**NSW GOVERNMENT** Planning & Environment  
 Issued under the Environmental Planning and Assessment Act 1979  
 Approved Section 4.55 (1A) Modification Application  
 No. 3 granted on the 24/10/18  
 in respect to SSD 7075  
 Signed [Signature]  
 Sheet No. 1 of 4

PROJECT :  
**ERSKINE PARK RMF - STAGE 1**  
**WASTE TRANSFER STATION**  
 FOR  
**CLEANAWAY WASTE**  
**MANAGEMENT LTD**

SITE LAYOUT - CONCEPT PLAN		DATE MARCH 2018	
FULL SITE DEVELOPMENT - MOD 3		SCALE AS SHOWN @ A3	
DEVELOPMENT CONSENT		PLOT SCALE 1 : 1	
DRWG. No.	DOCUMENTATION	SHEET. No.	REV.
17567	JH	103	05
	JH		
	ND

PROPOSED SITE LAYOUT - STAGE 1 - MOD 3		DATE MARCH 2018	
DEVELOPMENT CONSENT		SCALE AS SHOWN @ A3	
DRWG. No. <b>17567</b>	DOCUMENTATION JH DRAWN JH CHECKED ND	PLOT SCALE 1 : 1 SHEET. No. <b>003</b>	REV. <b>18</b>

**PROPOSED SITE LAYOUT**  
SCALE 1 : 1000

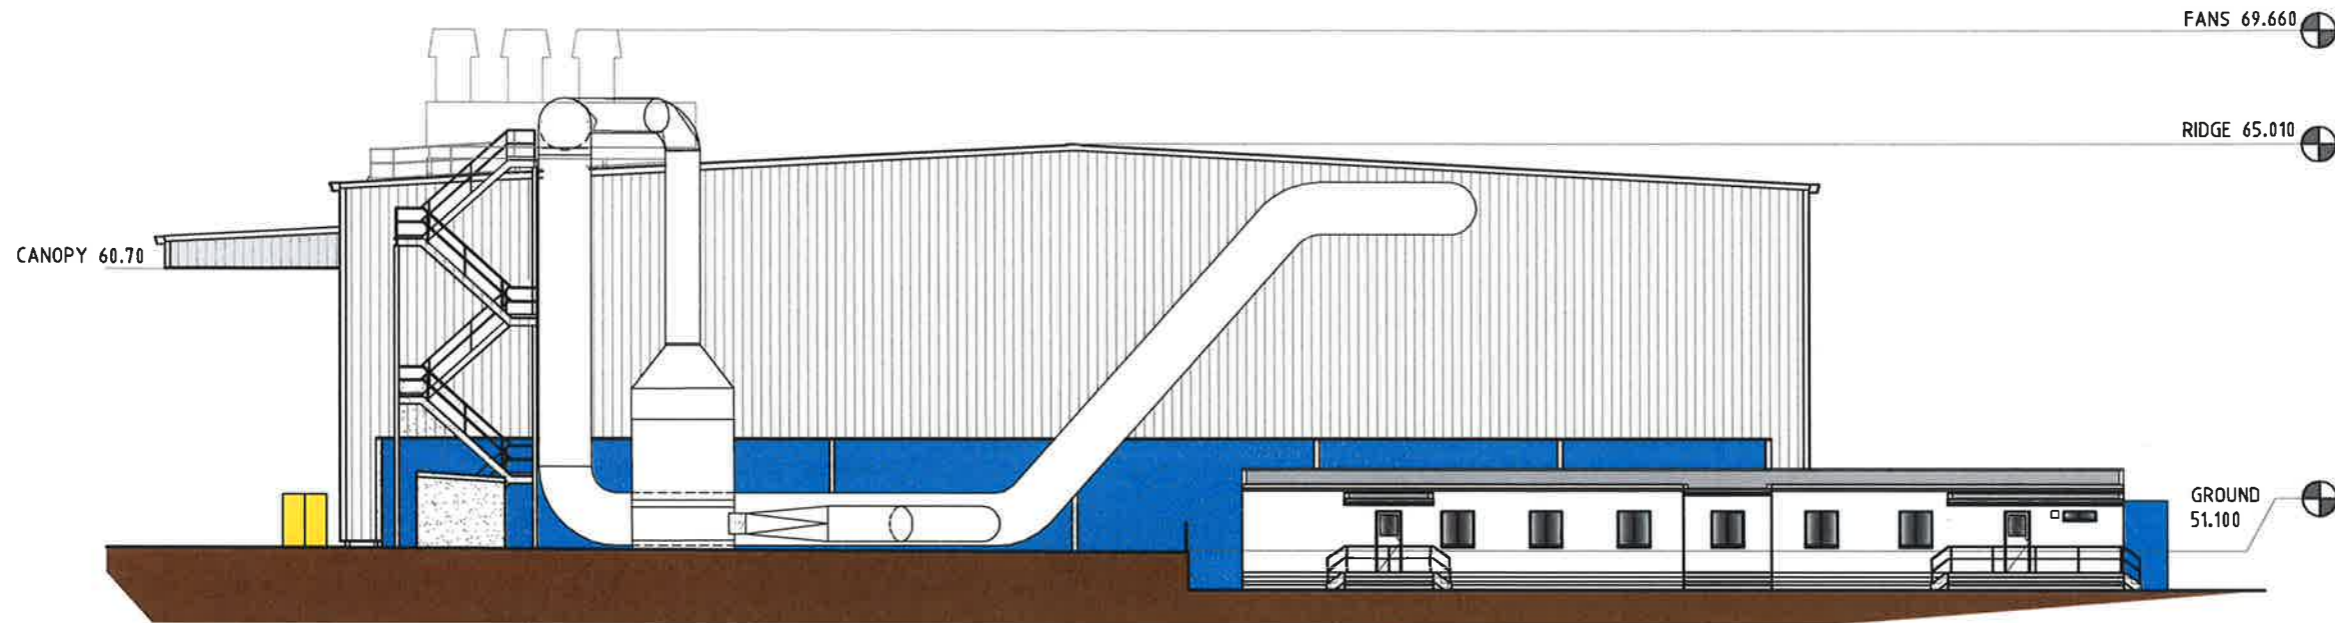
- SCHEDULE OF CHANGES**
1. ADDITIONAL TRUCK PARKING TO NTH DRIVEWAY
  2. OFFICE LAYOUT REVISED
  3. PROPOSED STAGE 2 ADDITION DELETED, 2x80KL RW TANKS NOTED
  4. DRIVERS REST ADDED TO STH DRIVEWAY
  5. NTH ELEVATION DUCT WORK REVISED
  6. ADDITIONAL STAGE 1 CAR PARKING
  7. EXISTING ACCESS ROAD IN STH WEST RETAINED
  8. EAST CANOPY RAISED BY 500MM
